FIRE SAFETY INSPECTION REPORT

TRIPPLE SEVEN

July 10, 2014

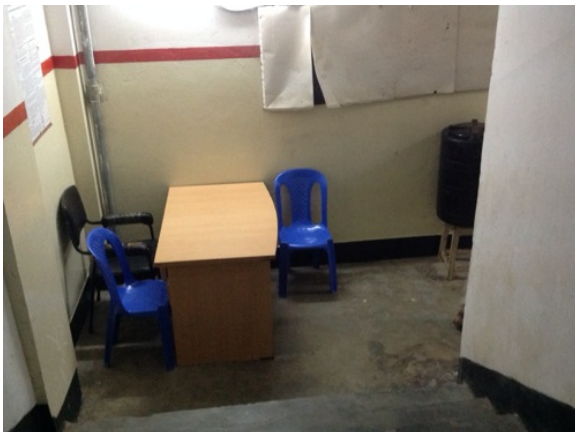
F-5	Fire Rated Construction	Unprotected vertical shift from floor 6 to floor 2.	Seal shift in fire rated construction.	Within 6 months
-----	-------------------------	---	--	-----------------

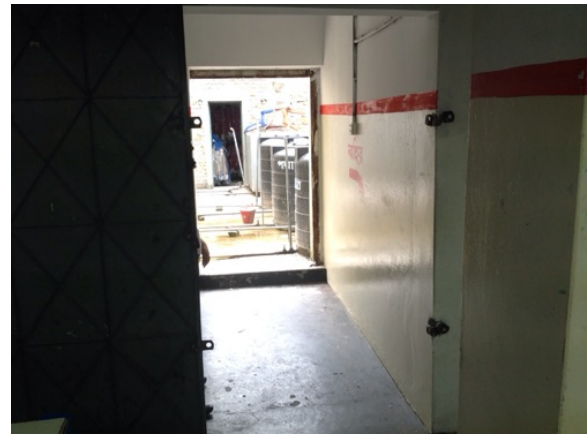
F-8	Egress	Collapsible gates are provided at building exit discharge on all discharges on the ground floor.	Replace all gates and sliding doors along the means of egress with side-hinged, swinging egress doors. If locks are required for security reasons, utilize special door locking features complying with NFPA 101.	Within 1 month
-----	--------	--	---	----------------

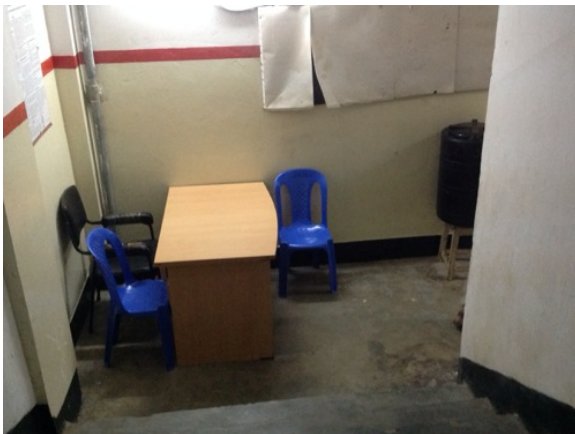
F-10	Egress	Handrails are not provided in the exit stair. This was observed in the center stairwell all floors.	Provide handrails on at least one side of exit stair.	Within 3 months
------	--------	---	---	-----------------
